1R - 425-1

**GENERAL
CORRESPONDENCE**

RE: Rice Operating Company
Vacuum E-2 Junction Box
Unit E Sec 2 T18S R35E
OCD Case Number 1R0425-01
Corrective Action Plan

Corrective Action Plan

unit 'E', section 2, T18S, R35E
Excavation Cross-Section

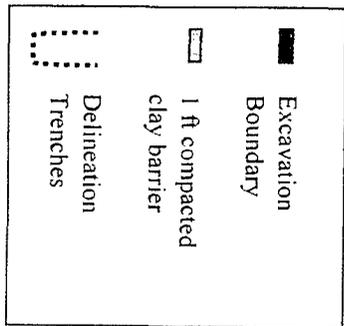
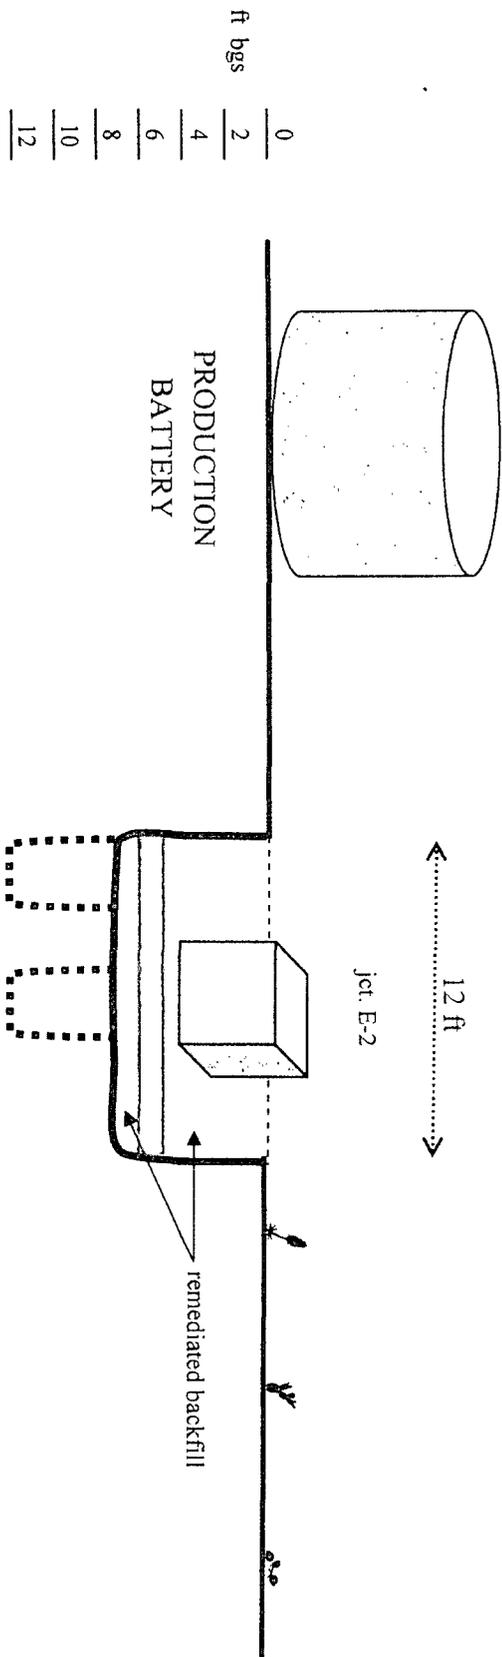
As constructed cross-sections of clay liners: Please find the attached images for each site, which were prepared t I have also included photographs to supplement the drawings.
